Project	<b>IEEE 802.16 Broadband Wireless Access Working Group</b> < <a href="http://ieee802.org/16">http://ieee802.org/16</a> >	
Title	<b>Changes on Sleep Mode SDLs and MSCs</b>	
Date Submitted	<b>2004-1-8</b>	
Source(s)	Chulsik Yoon, Jaeheung Kim, Kunmin Yeo ETRI 161 Gajeong-Dong, Yuseong-Gu, Daejeon, Korea	Voice: +82-42-860-6826 Fax: +82-42-860-6732 mailto: <a href="mailto:csyoon@etri.re.kr">csyoon@etri.re.kr</a>
Re:	This is a response to a Call for Comments IEEE 802.16e-03/58 on IEEE 802.16e-03/07r5	
Abstract	This document contains suggestions to change the SDLs and MSCs reflecting working groups agreements on the Sleep Mode operation.	
Purpose	The document is submitted for review by 802.16e Working Group members.	
Notice	This document has been prepared to assist IEEE 802.16. It is offered as a basis for discussion and is not binding on the contributing individual(s) or organization(s). The material in this document is subject to change in form and content after further study. The contributor(s) reserve(s) the right to add, amend or withdraw material contained herein.

# Changes on Sleep Mode SDLs and MSCs

## 2. Proposed changes on Sleep Mode operation SDLs and MSCs in IEEE 80

Figure 108n – BS-SS Sleep Mode SDL Diagram

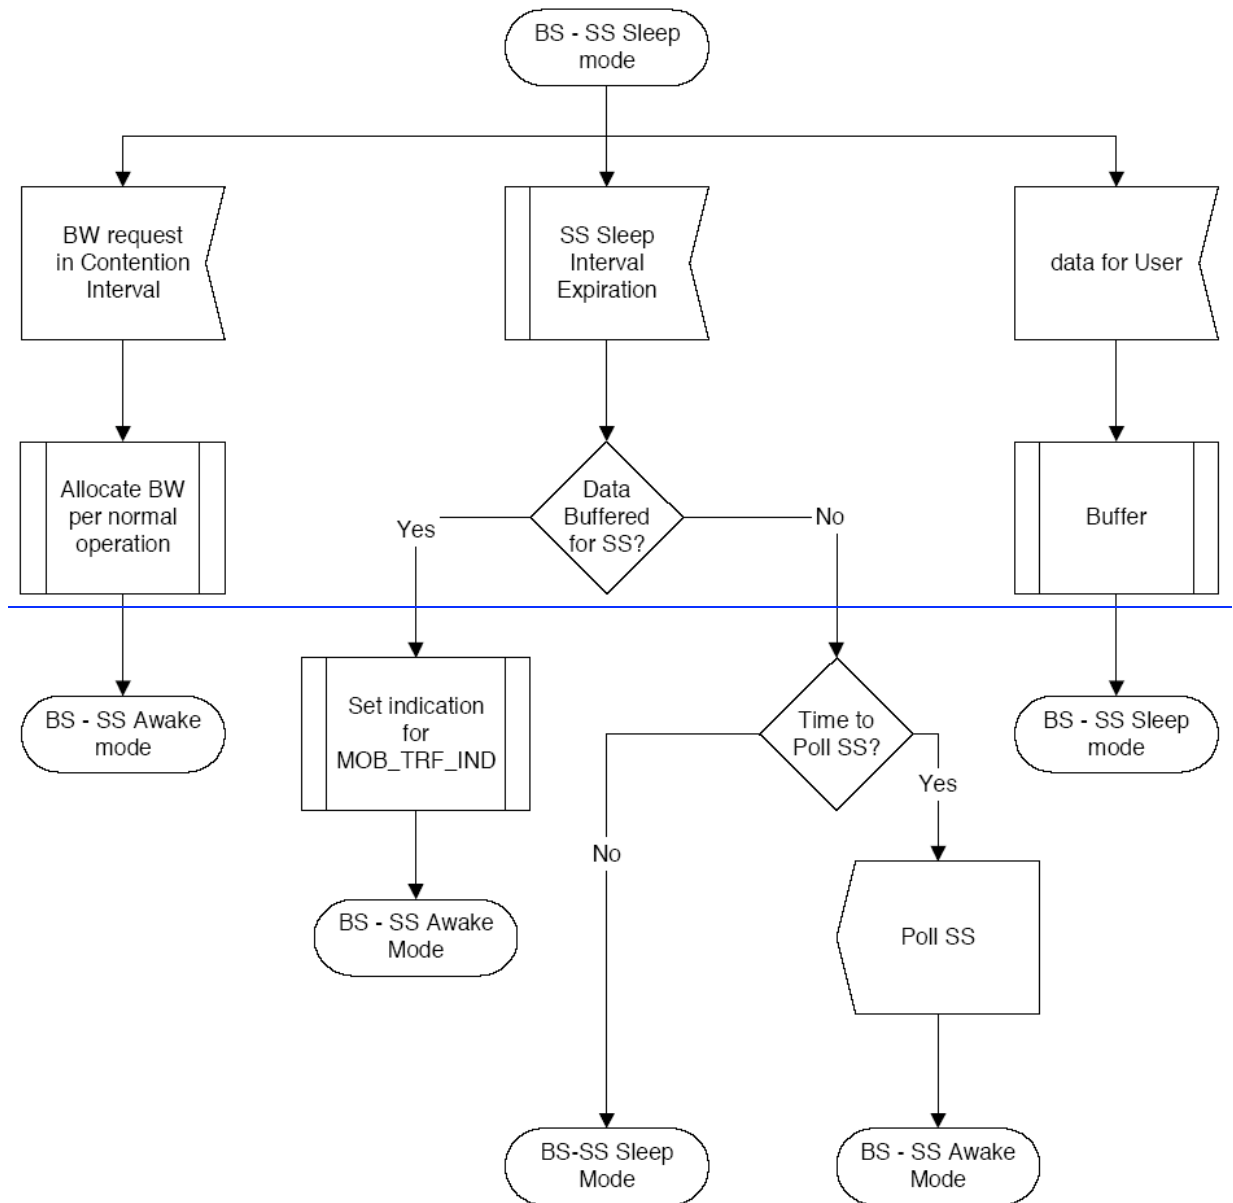
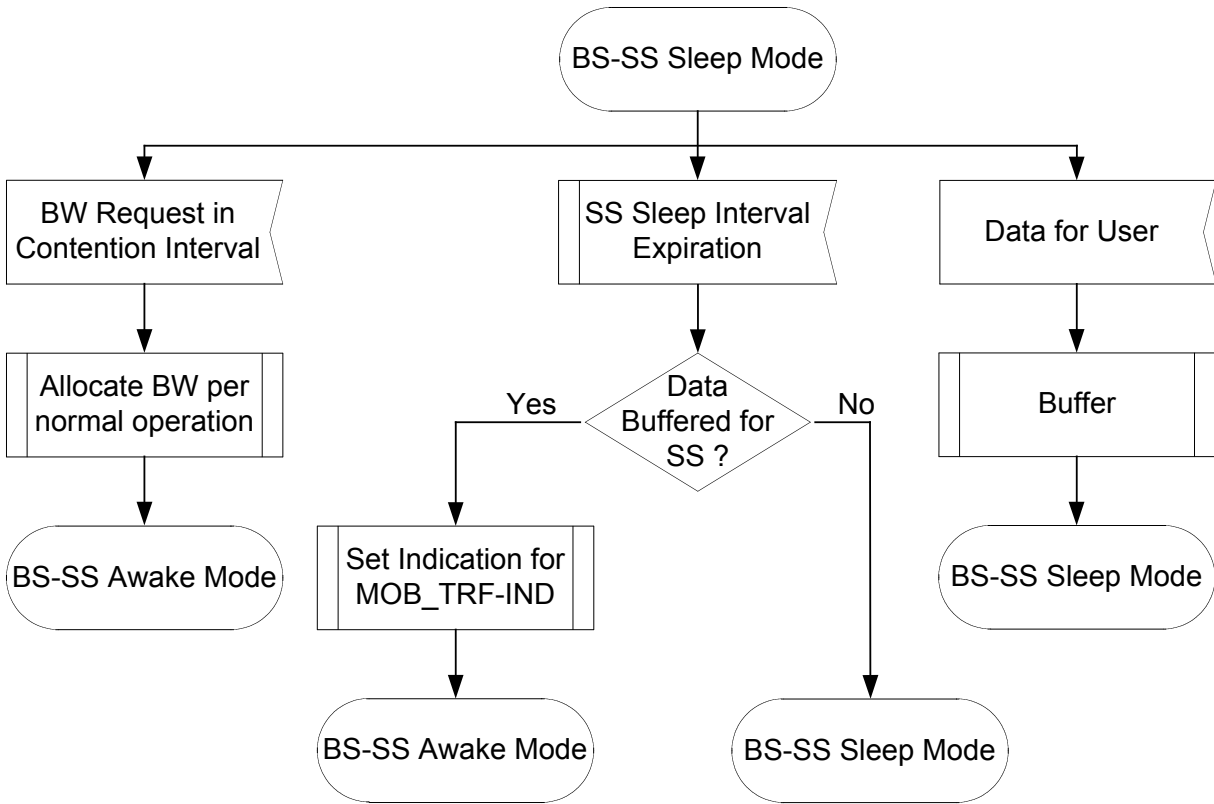
[Replace Figure 108n to the following:]  
 [From:]

~~Figure 108n - BS-SS Sleep Mode SDL Diagram~~

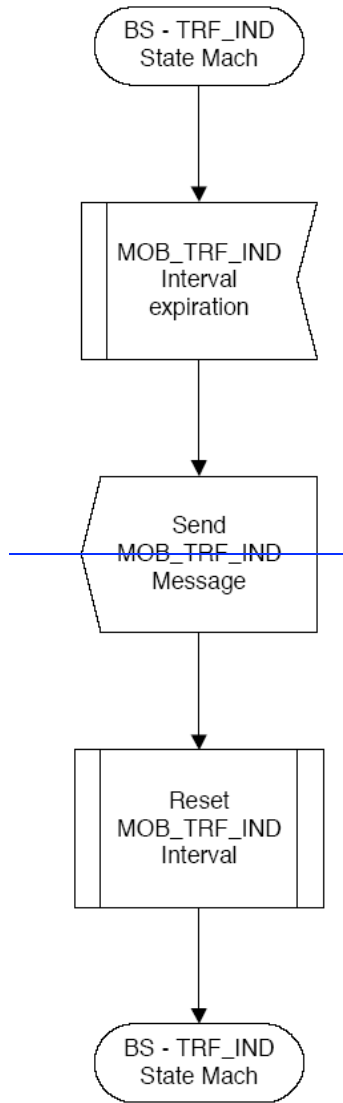
*[Delete Figure 108o:]*

Figure D.11 – Sleep Mode – MSS initiated

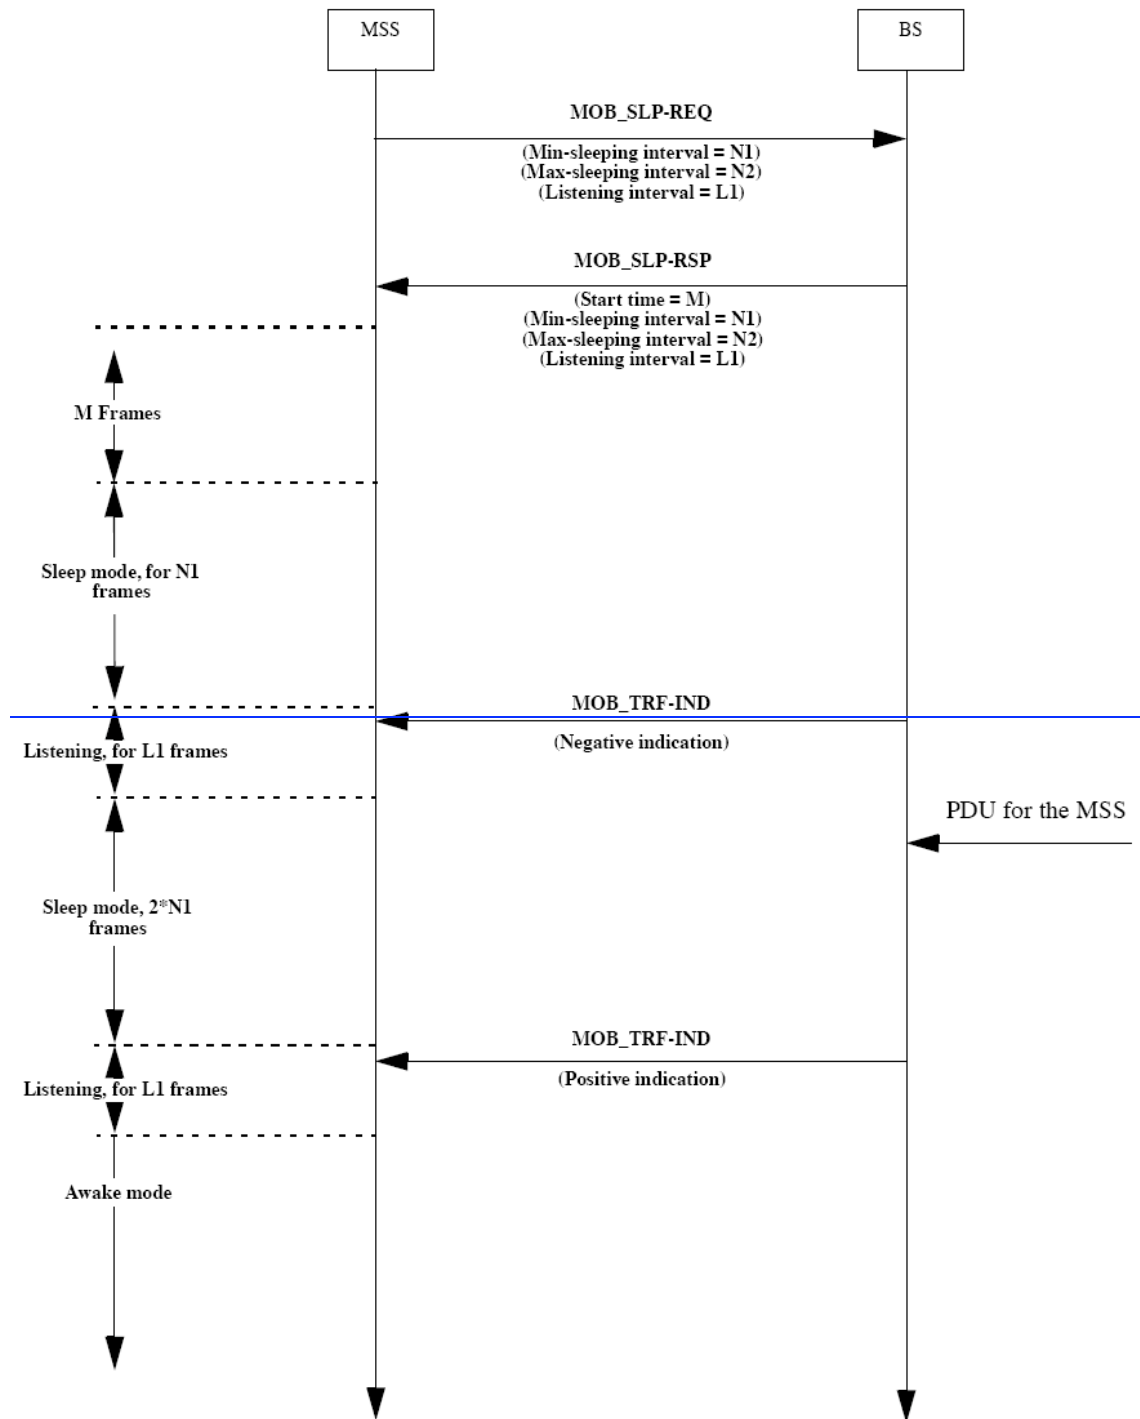
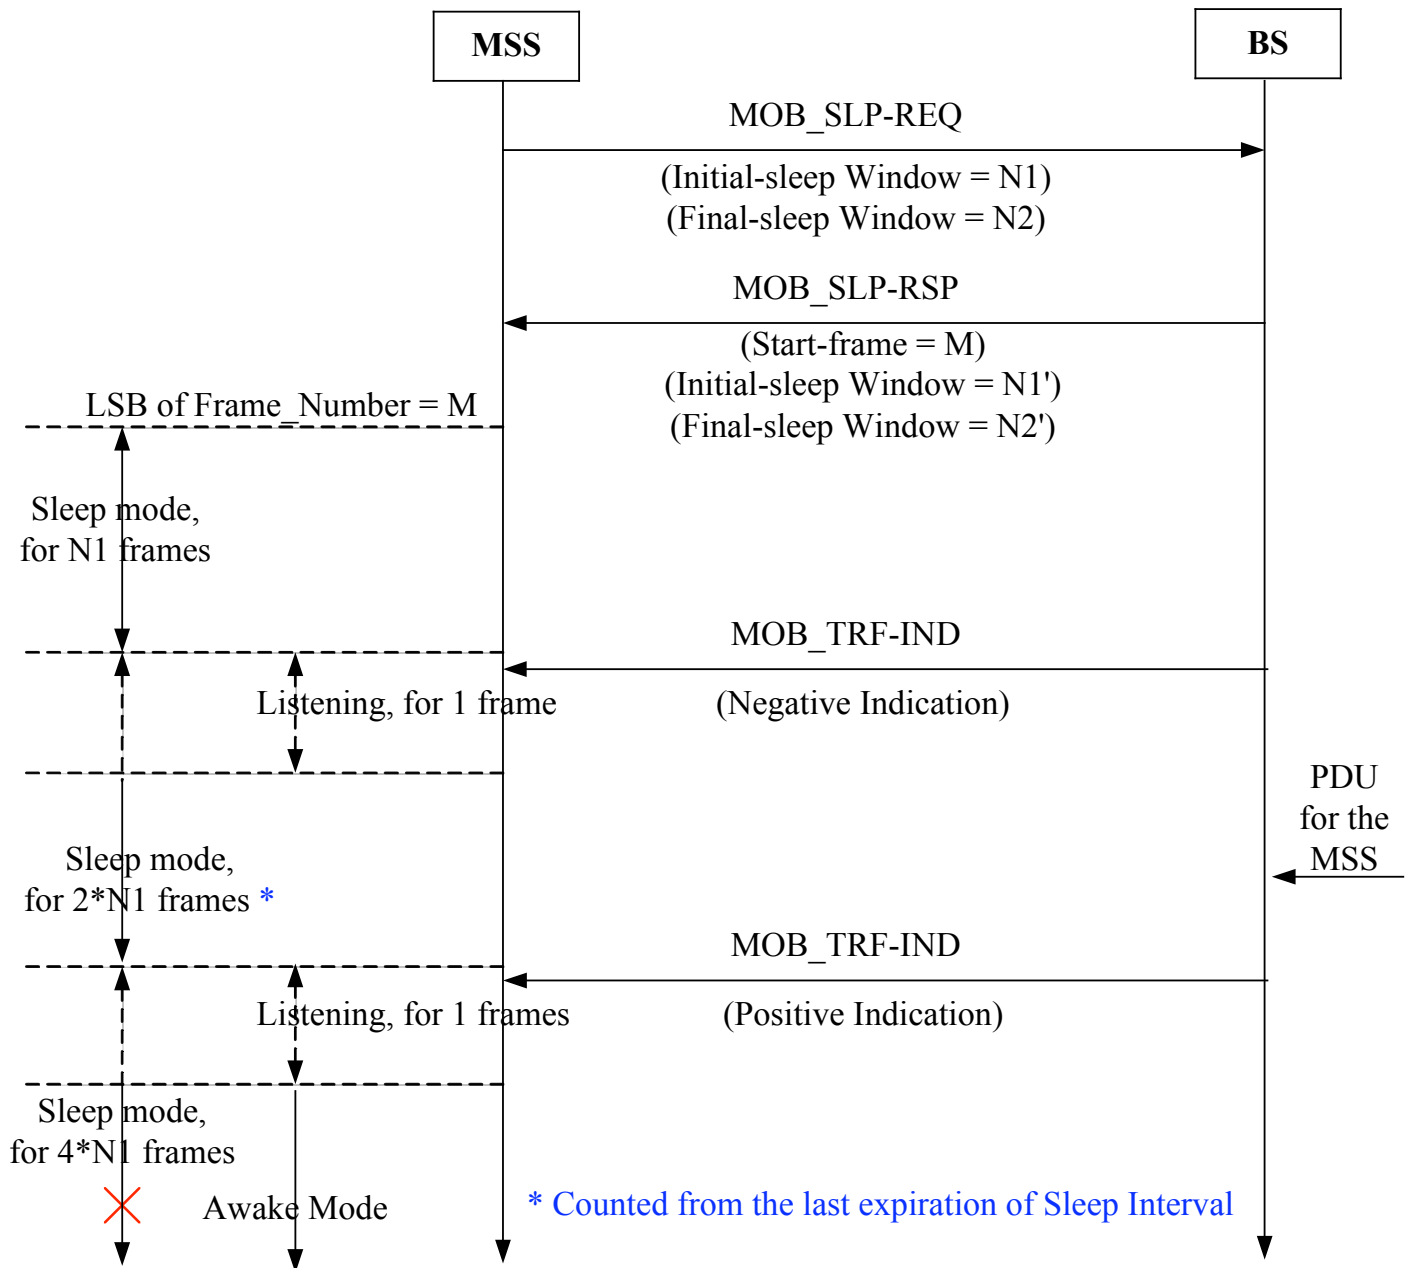
[Replace Annex D.2 Figure D.11 to the following:]  
 [From:]

Figure D.12 – Sleep Mode – BS initiated

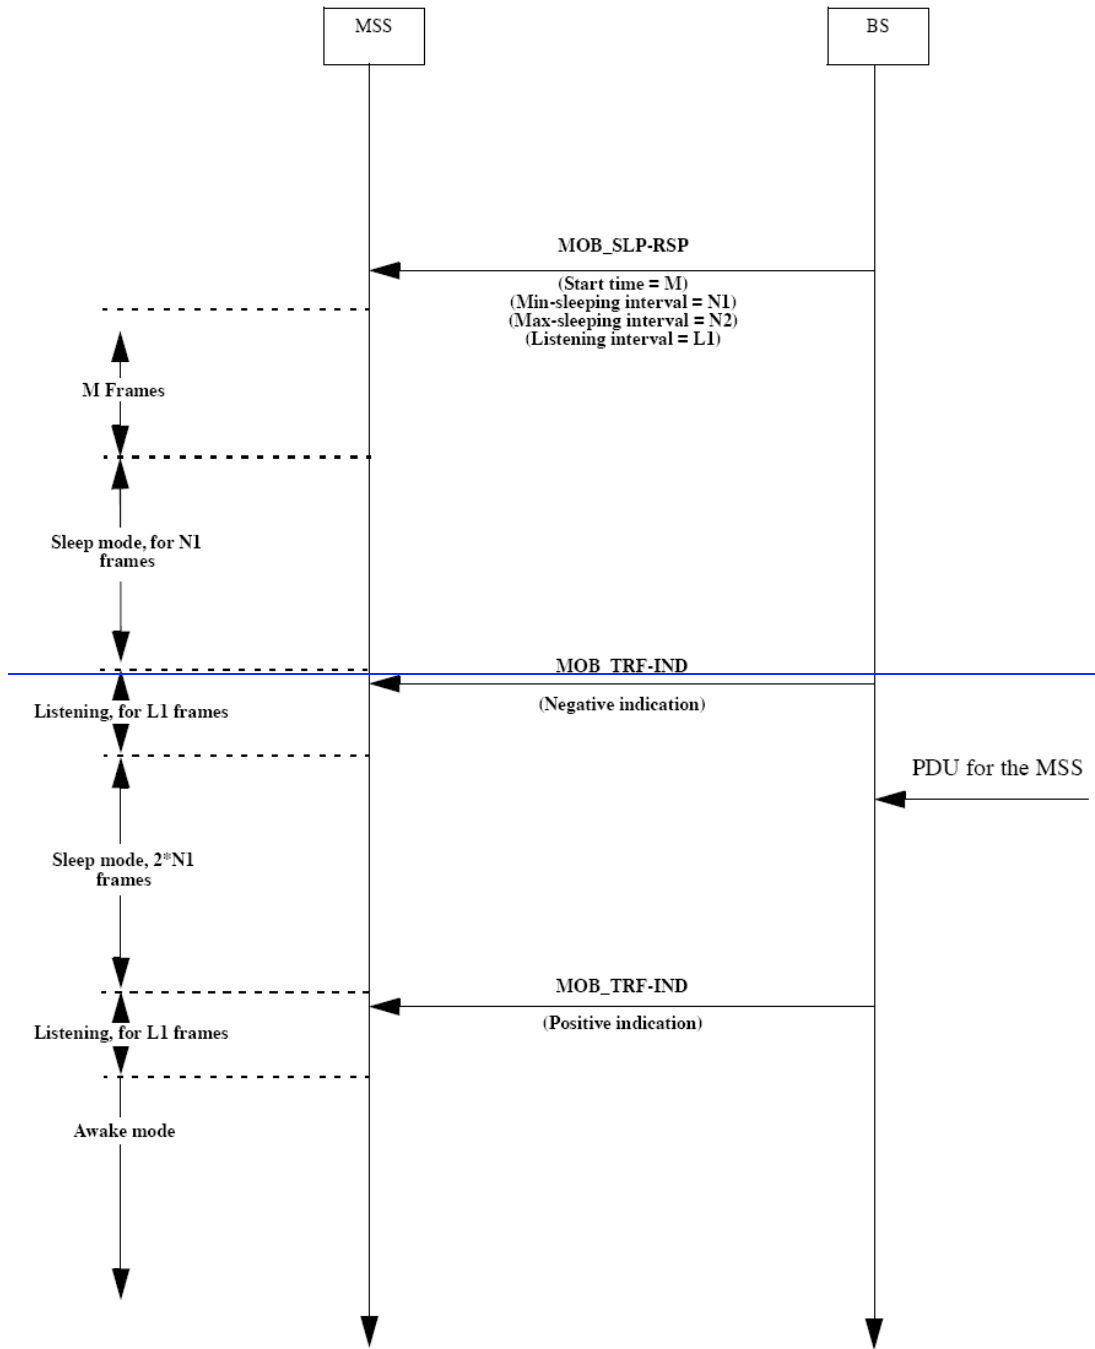
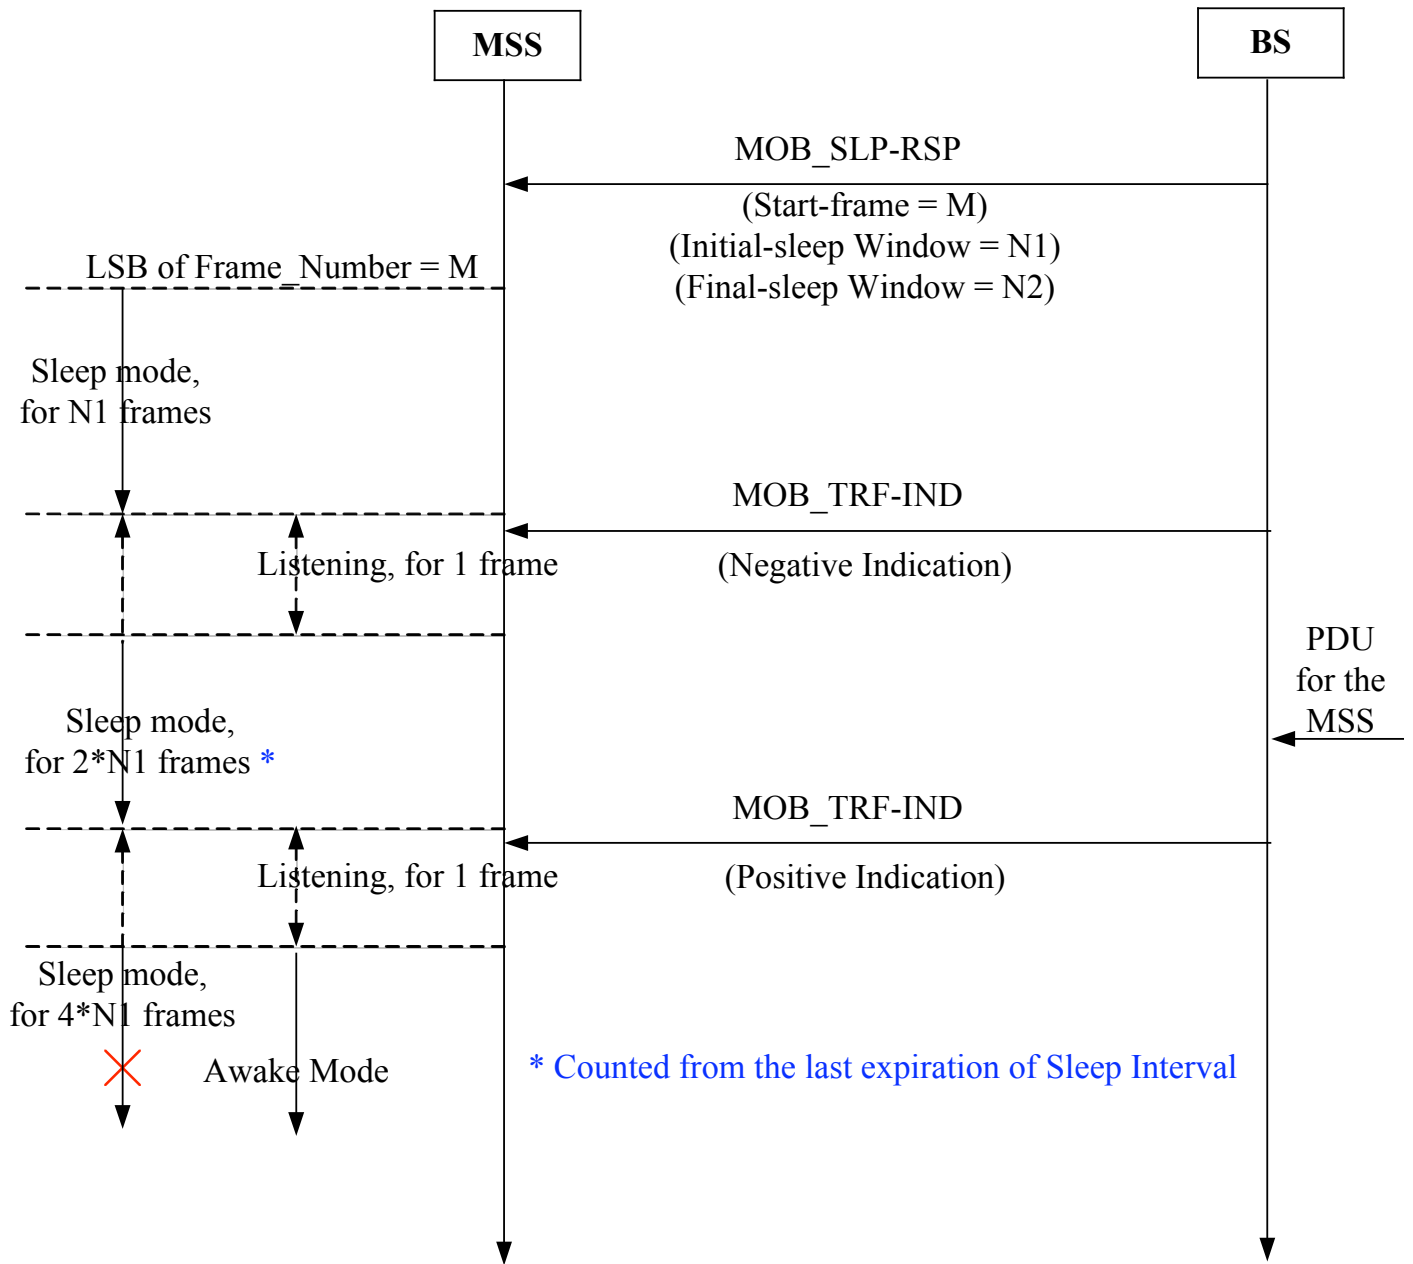
[Replace Annex D.2 Figure D.12 to the following:]  
[From:]
